# SERVICE BULLETIN NO. 10

SUBJECT: Oil Loss Through Breather Ass'y-Vertical Shaft Gem Engines.

FIGURE 1.

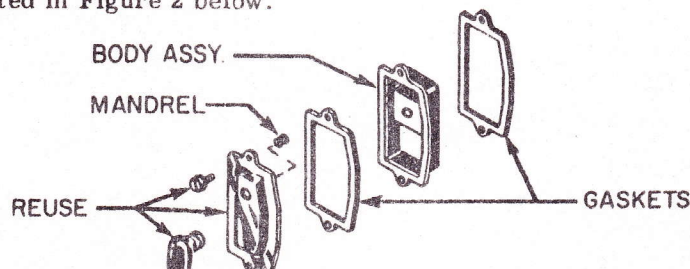
- A. The oil capacity for a vertical shaft Gem or Clintalloy engine is a **maximum** of one pint of oil. This can be checked with the engine base level. The oil level is **2-1/2 to 3 threads** from the top of the oil fill (Fig. 1) and an oil level above this will result in loss of oil through the breather assembly. This is especially true on engines with camshaft slinger lubrication.
